## Official Notification - Federal Boat Safety Act Flywheel Replacement 1991 100 thru 200 HP Models

### 1991 Mariner and Mercury

Insert this page with Service Bulletin 93-2.

**Figure 1. Cast Iron Flywheel with Cracked Ring Gear**

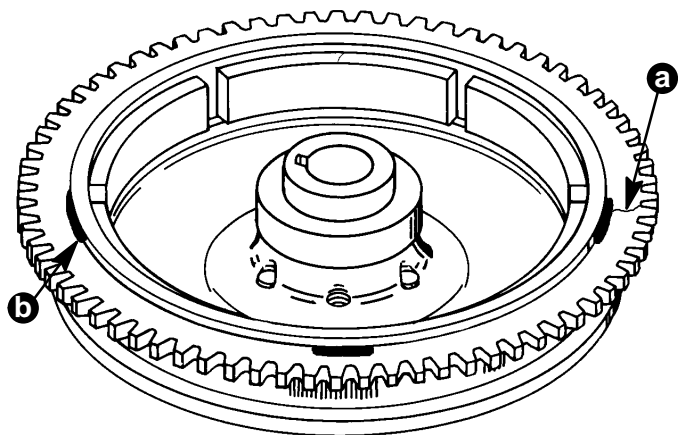
Cracked ring gears have been found on some 1991 100 thru 200 hp outboards. The outboards listed require replacement of the cast iron flywheel with non welded ring gear. The flywheel ring gear could crack and become detached from the flywheel. Not all 1991 100 thru 200 hp outboards are affected. Replacement is required only within the serial number ranges specified.

The crack will usually begin at one of the four welds and move outward.

Figure 1 illustrates how a cracked ring gear may appear just before it separates from the flywheel.

Replacement flywheels will not have welded ring gears. Welding of flywheel ring gears has been discontinued. As of July 1992 all 50 thru 200 hp flywheel ring gears are shrunk-on the flywheel.

1. Replace cast iron flywheel with new cast iron flywheel. Refer to Section 2A of Service Manual P/N 90-13645--2 (100-115-hp) or 90-816249--1 (135 thru 200 hp) for flywheel removal and installation instructions. Torque flywheel nut to 120 lb.ft. (163 N·m).
2. Refer to Section 2C of service manual and perform steps as listed under "Timing/Synchronizing/Adjusting".
3. US and Canada - return cast iron flywheel with completed warranty claim.  
International - follow instructions issued by Marine Power International office or by your distributor.

**Figure 2. 135-200 Flex-Plate Flywheel (Not Affected)**

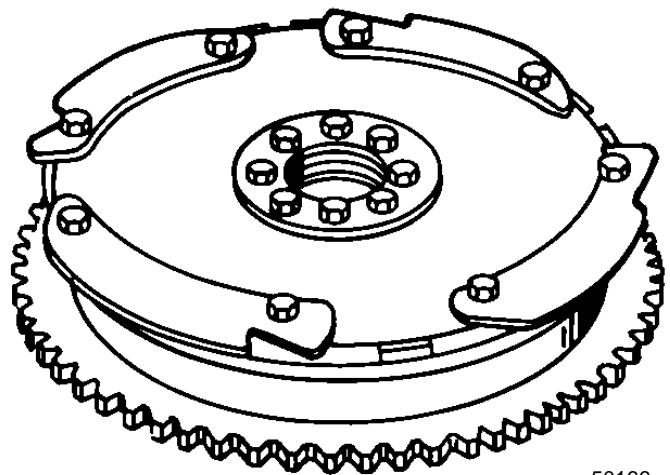
V-6 outboards within the serial number range that are equipped with flex-plate style flywheels, as shown in Figure 2, are not affected.

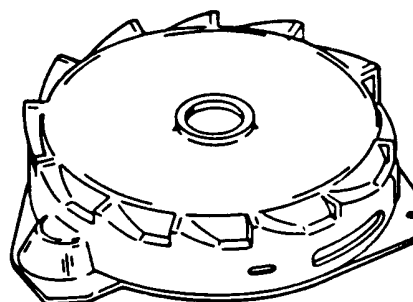
We have received calls asking how to determine if a 16 amp. flywheel or a 40 amp. flywheel is to be ordered for the 135 thru 200 product. In the parts manual, we show an illustration of the flywheel cover to make the identification of the systems easy. The outboards with the solid flywheel cover have the 16 amp. charging system. The outboards with the louvered flywheel cover have the 40 amp. charging system.

Solid Flywheel Cover  
for 16 Amp. system.  
Order 271-817632A-4 Flywheel

Louvered Flywheel Cover  
for 40 Amp. system.  
Order 271-817632A-2 Flywheel
